# Value Engineering Study Report

*Projects – STP-2387(4) & CSNHS-0007-00(421)  
P.I. No. 542070 & P.I. 0007421*

*Widening of SR 251  
Reconstruction of the I-95 and SR 251 Interchange  
McIntosh County*

RE: Submittal of the final Value Engineering Report  
Projects – STP-2387(4) & CSNHS-0007-00(421)  
McIntosh County  
P.I. No. 542070 & P.I. No. 0007421  
Widening of SR 251 and Reconstruction of I-95 and SR 251 Interchange  
PBS&J Project Task Order No. 26

<b>PROJECT:</b> Georgia Department of Transportation CSNHS-0007-00(421) – P.I. No. 0007421 I-95 and SR 251 Interchange – McIntosh County	<b>ALTERNATIVE NO.:</b>  <b>BR-1</b>
<b>DESCRIPTION:</b> USE A 10' FLUSH SHOULDER	<b>SHEET NO.:</b> 1 of 4

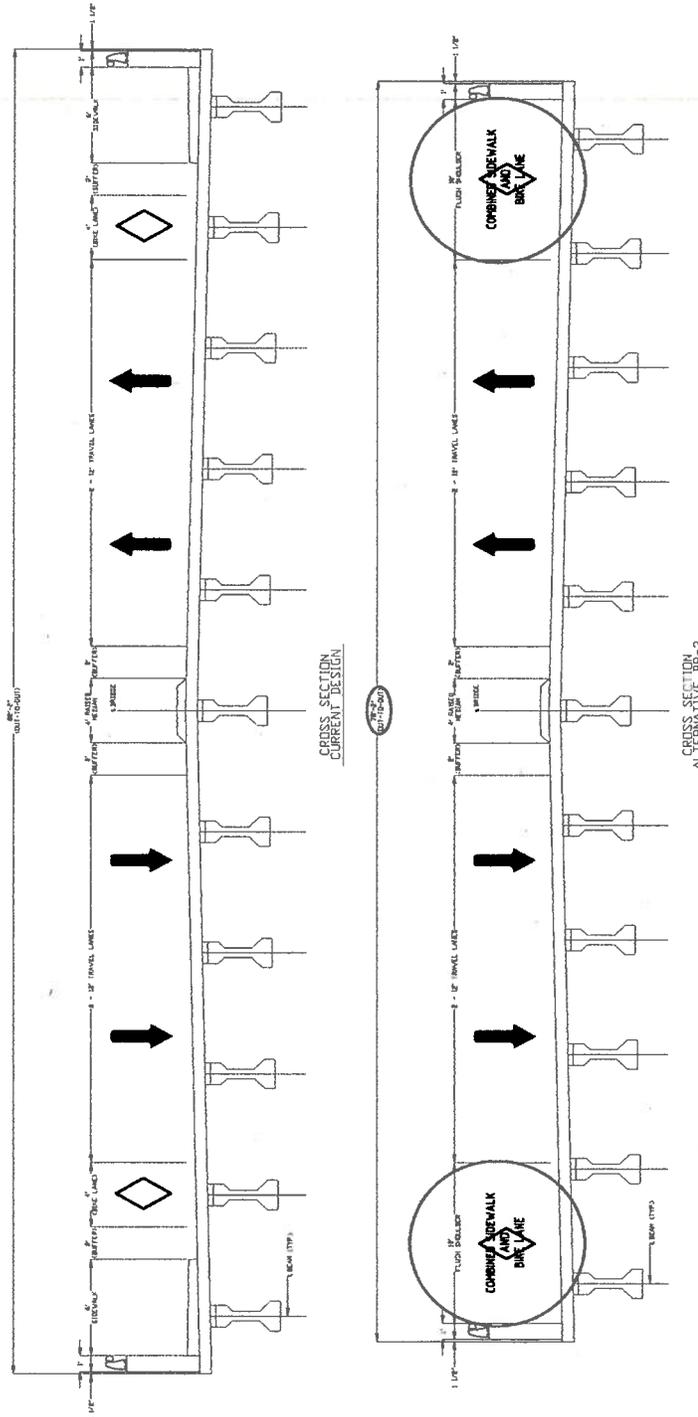
Utilizing a flush shoulder across the bridge will provide several benefits beyond mere cost savings. The flush shoulder will accommodate the bike and pedestrian traffic, but could also be utilized by cars and trucks during emergency situations. The flush section will provide reduced cost and easier construction sequencing if the roadway is widened in the future. If asphalt pavement is used in lieu concrete or asphalt shoulders are used in the interchange, an additional savings of approximately \$150,000.

<b>PROJECT:</b>	<b>Georgia Department of Transportation</b> <b>CSNHS-0007-00(421) – P.I. No. 0007421</b> <b>I-95 and SR 251 Interchange – McIntosh County</b>	<b>ALTERNATIVE NO.:</b>	<b>BR-3</b>
<b>DESCRIPTION:</b>	<b>USE A 14' CENTER TURN LANE WITH NO SEPARATION</b>	<b>SHEET NO.:</b>	1 of 4

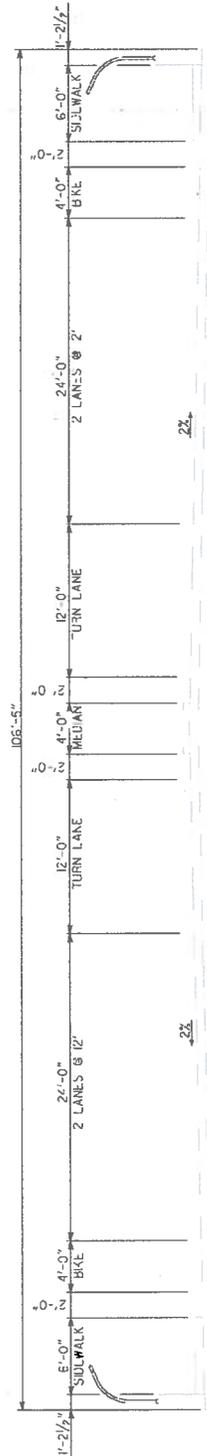
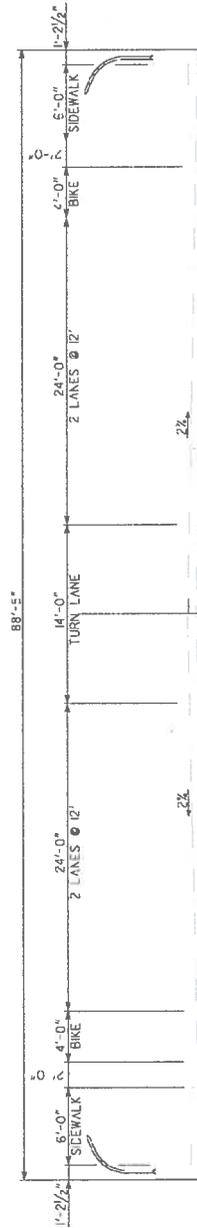
The revised superstructure will accommodate on each side a concrete side barrier of special design with a chain link fence, 6' raised sidewalk, 2' buffer, 4' bike lane, 2 – 12' travel lanes, a 14' back-to-back turn lane and a 2' buffer.

PROJECT:	<b>Georgia Department of Transportation CSNHS-0007-00(421) – P.I. No. 0007421 I-95 and SR 251 Interchange – McIntosh County</b>	ALTERNATIVE NO.:	<b>BR-4</b>
DESCRIPTION:	<b>REDUCE DISTANCE TO END BENTS TO 20' AND USE PIER PROTECTION AND GUARD RAILS</b>	SHEET NO.:	1 of 4

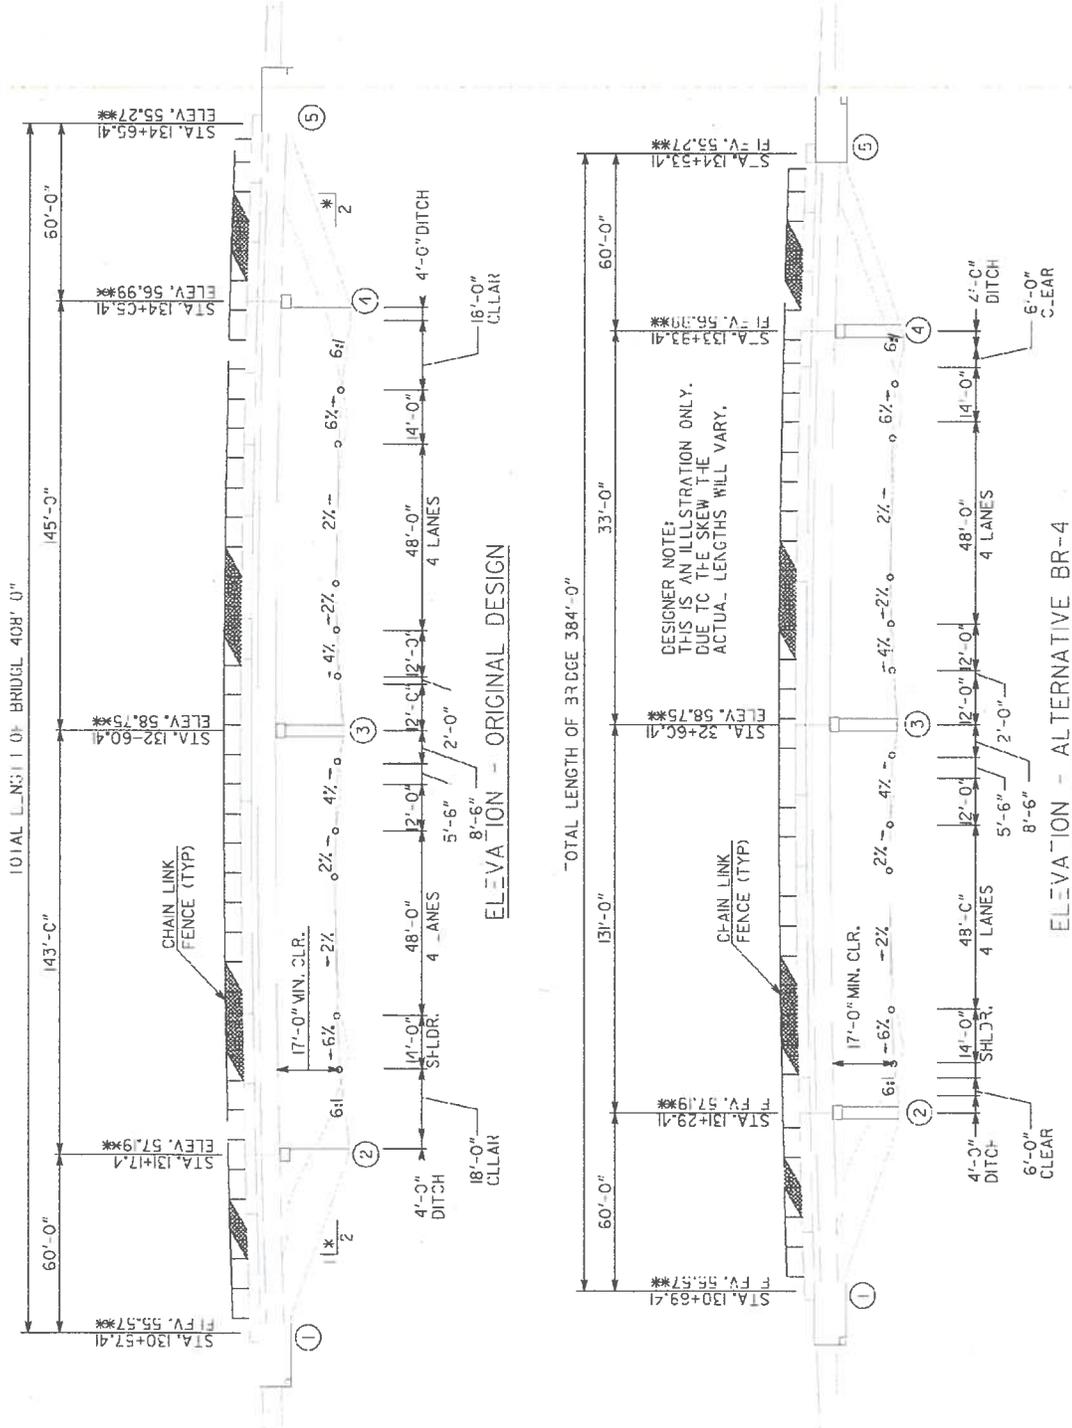
By moving the end spans inward by 12' on each side the revised span arrangement will reduce the bridge length by 24'. The end spans will remain at 60' and comprise of Type II AASHTO Girders while the intermediate spans will be approximately 131' and 133' each and comprise of BT 74 Girders. Additionally, an opportunity may exist to use shallower beams (BT 63) resulting in lowering the profile which will be highly beneficial to the overall interchange configuration. This opportunity may have to be further investigated by the design team.

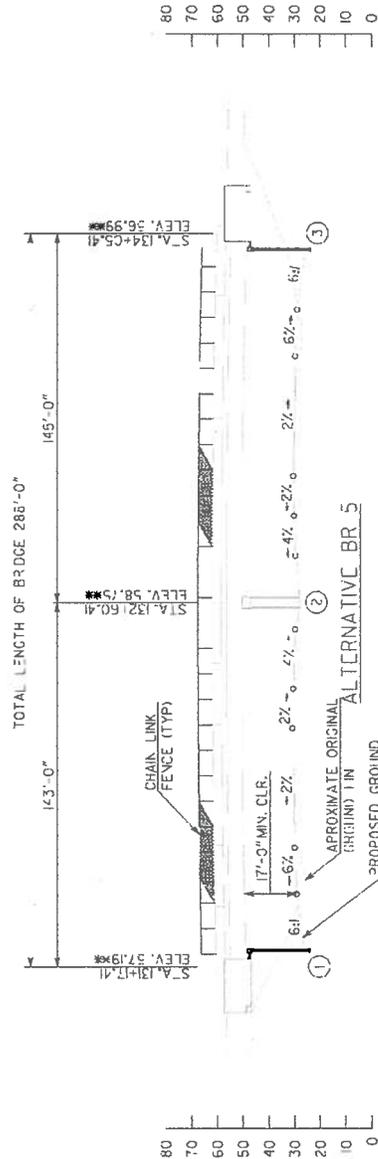
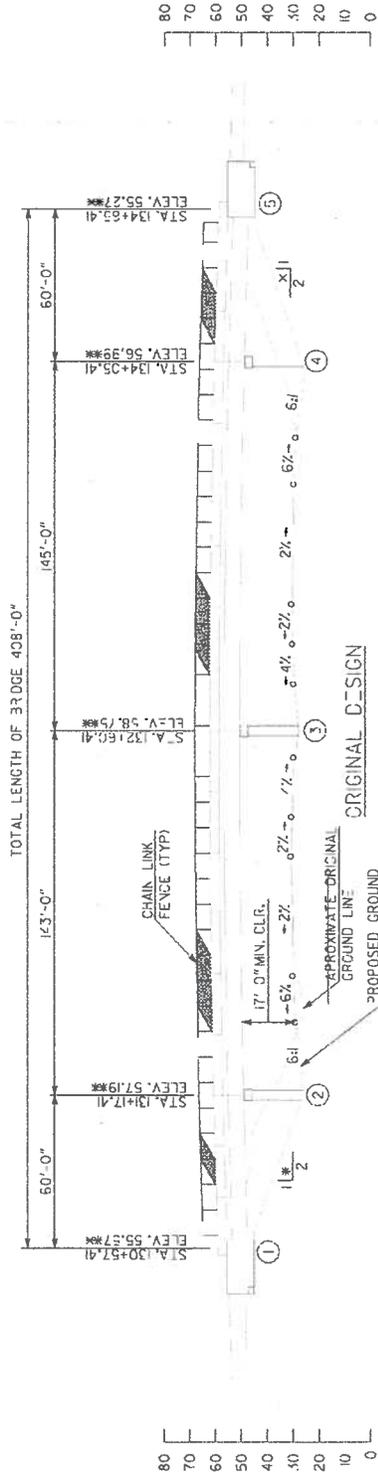
By eliminating the end spans on each side and providing MSE Walled abutments in place of the current Bents 2 and 4, the total bridge length reduces to 288'. Type 7-C side barriers may be used to protect the MSE Walls. The 4' ditch can be replaced by a buried pipe to channel runoff across the bridge footprint. The 143' and 145' spans remain the same.

PROJECT:	<b>Georgia Department of Transportation CSNHS-0007-00(421) – P.I. No. 0007421 I-95 and SR 251 Interchange – McIntosh County</b>	ALTERNATIVE NO.:	<b>BR-9</b>
DESCRIPTION:	<b>REDUCE END SPANS TO 40'</b>	SHEET NO.:	1 of 4

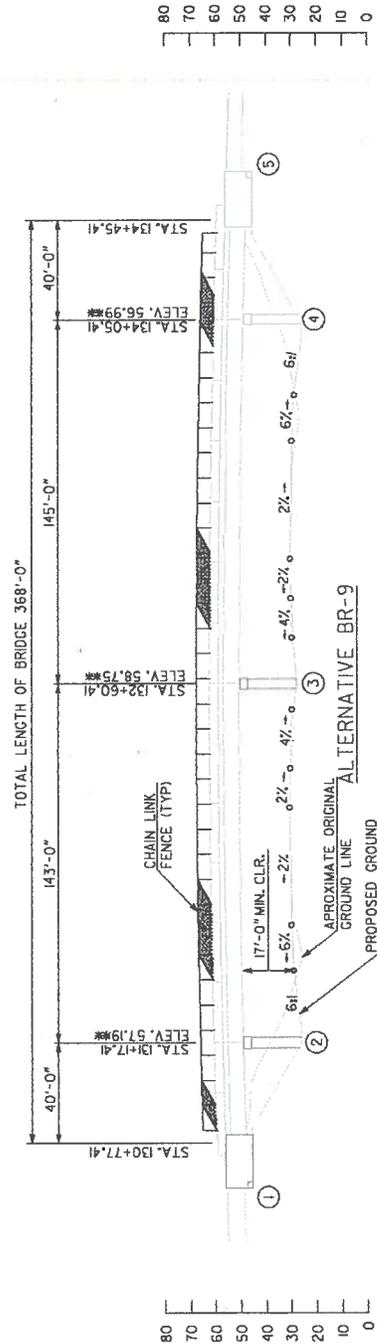
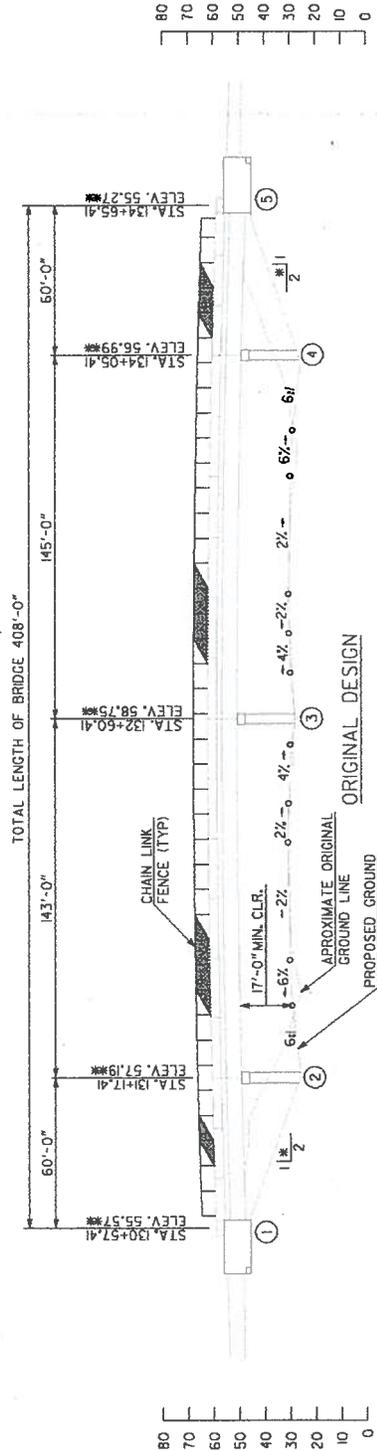
The new bridge replaces an existing 2 lane bridge and is built 6' higher to provide adequate vertical clearance to widened I-95 lanes. Also, the distance from the edge of I-95 travel lane to the first interior pier is 36' (14' shoulder + 18' clear + 4' ditch).

PROJECT: <b>Georgia Department of Transportation CSNHS-0007-00(421) – P.I. No. 0007421 I-95 and SR 251 Interchange – McIntosh County</b>	ALTERNATIVE NO.:  <b>RD-1</b>
DESCRIPTION: <b>USE ASPHALTIC CONCRETE IN LIEU OF CONCRETE</b>	SHEET NO.: <b>1 of 3</b>

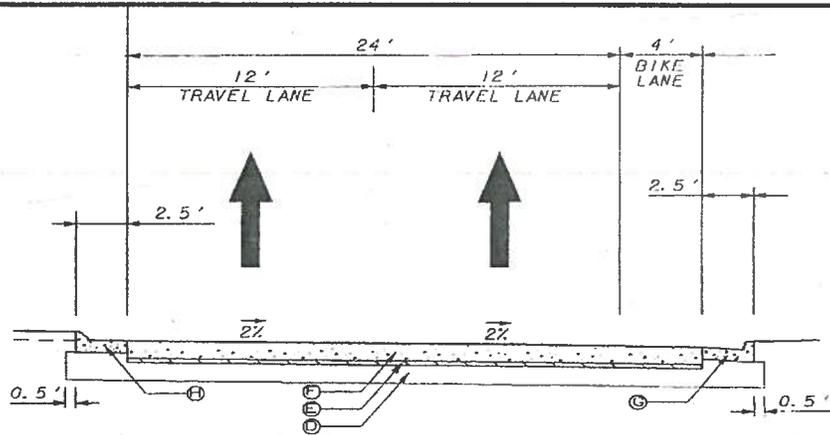
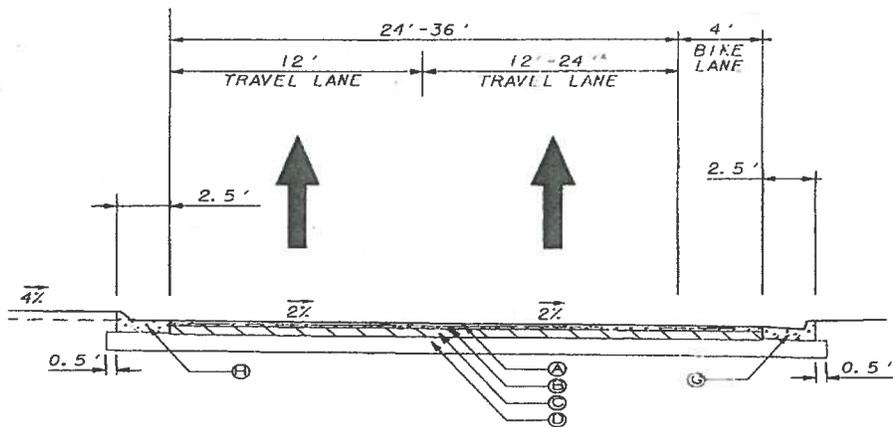
**REQUIRED PAVEMENT**

ALTERNATIVE NO.:  
RD-4

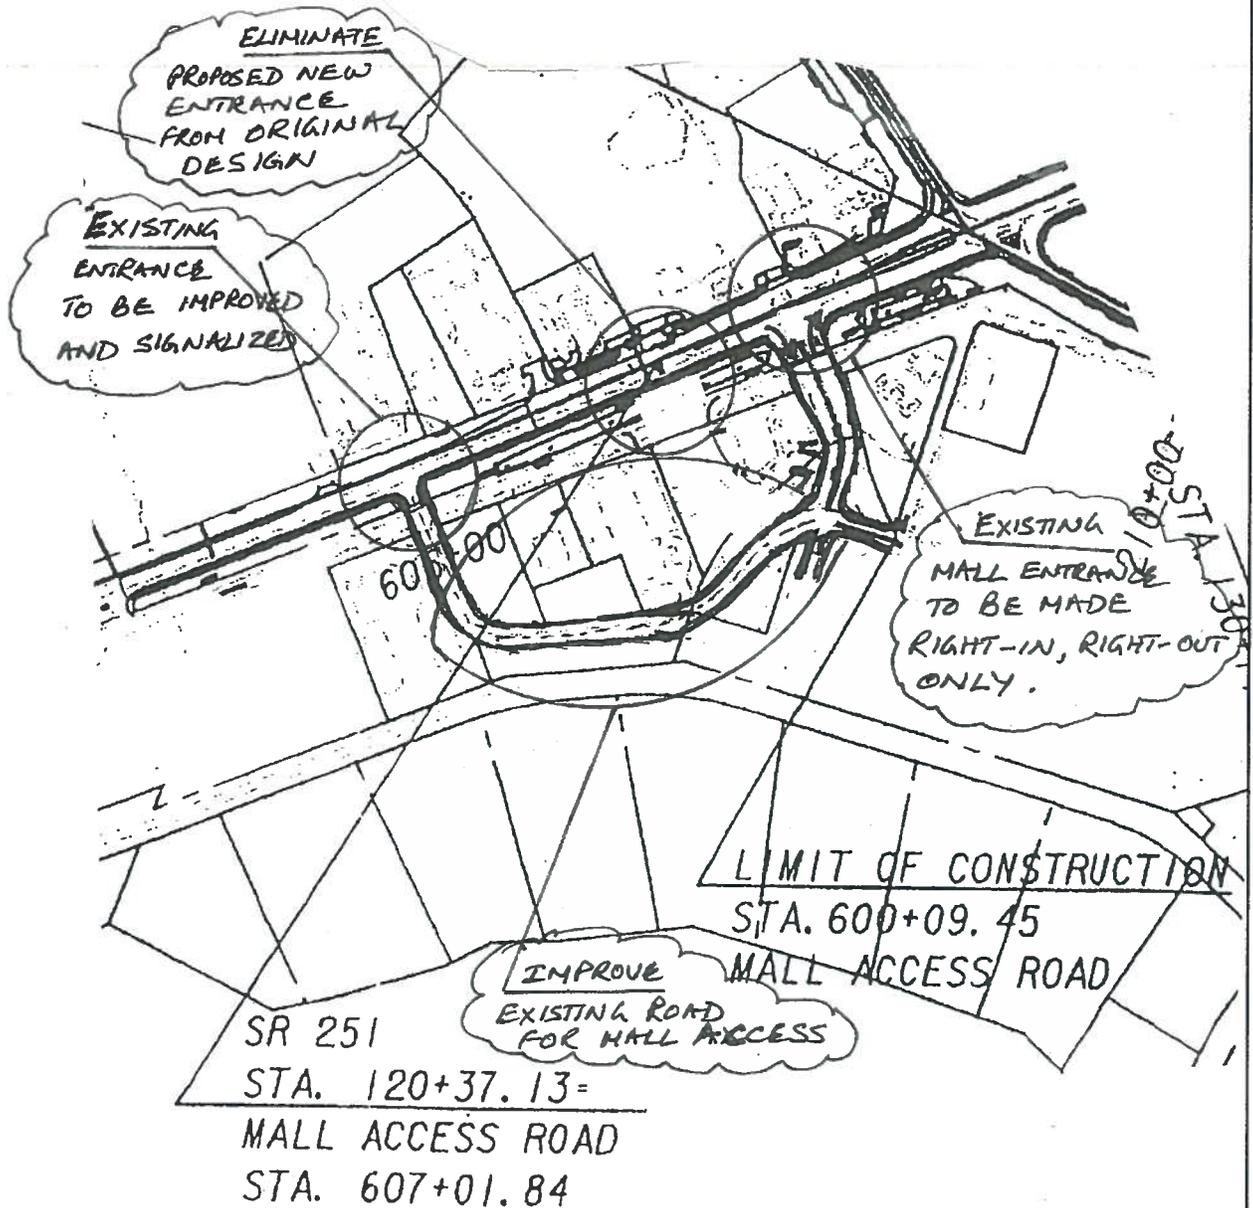
The present design constructs a new entrance to the existing mall to move its entrance westerly to provide additional turning storage into the mall as well as onto I-95. However, at its present location, it requires the taking of an existing restaurant and results in entering SR 251 directly opposite the exit of the existing truck stop. This situation could result in a significant conflict between truckers leaving the truck stop and merging with the exiting mall traffic as well a traffic entering the mall. By moving the new mall entrance further to the west, to its existing location, the conflict between crossing traffic should be lessened and if it is practical to provide a right-out at the malls present location, most all conflict would be negated, and potentially, a signal may not be necessary. It appears reasonable to presume that the basic savings for this would be the cost of the right-of-way as the construction costs for the new entrances would be approximately the same.

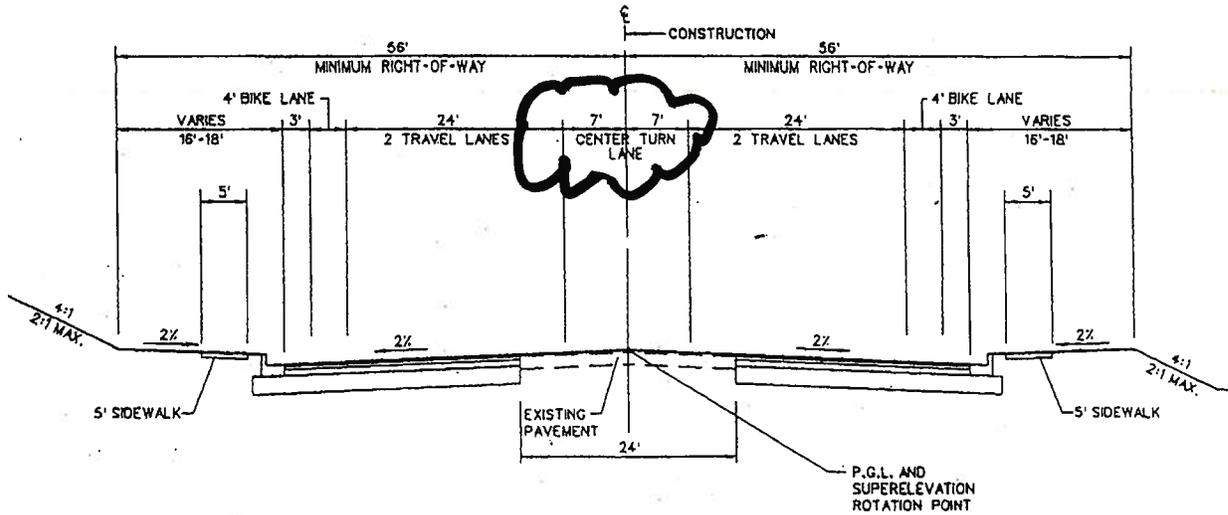
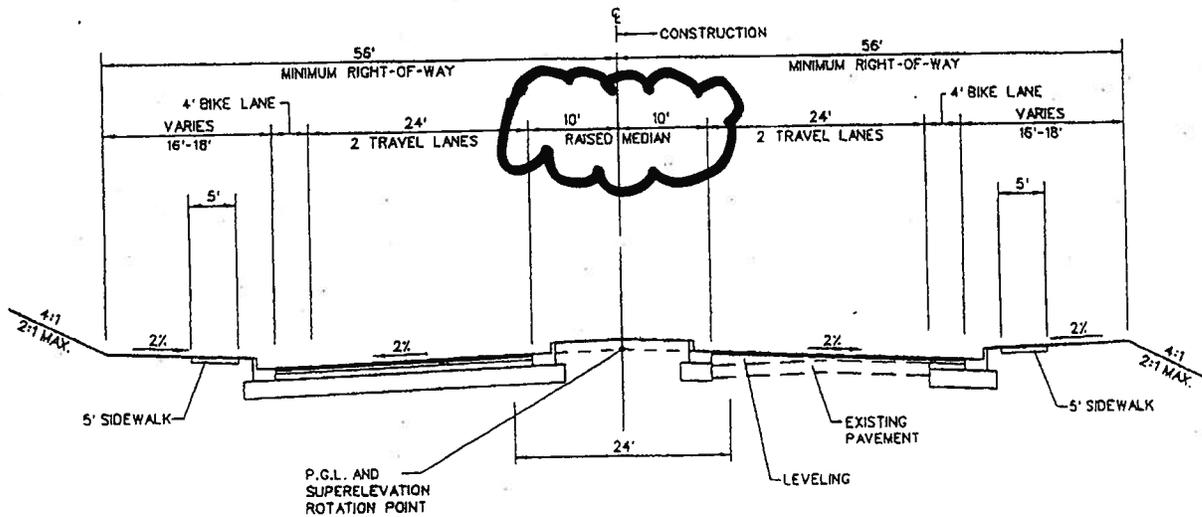
The designer proposes building a 5 lane roadway with a typical section that is 80' face of curb to face of curb. This dimension is the same as the typical section with a 20' raised median. The additional 6' is accommodated by increasing the bike lanes 7'-0". A bike lane of 7'-0" is wide enough to potentially encourage automobiles to use this as a lane creating a safety hazard for bicyclists and other automobiles. The section of roadway between the raised median currently proposed is largely residential or undeveloped and access should not be an issue. Future development of this property could pose future access management issues. Construction of a raised median section will reduce costs with little negative impacts.
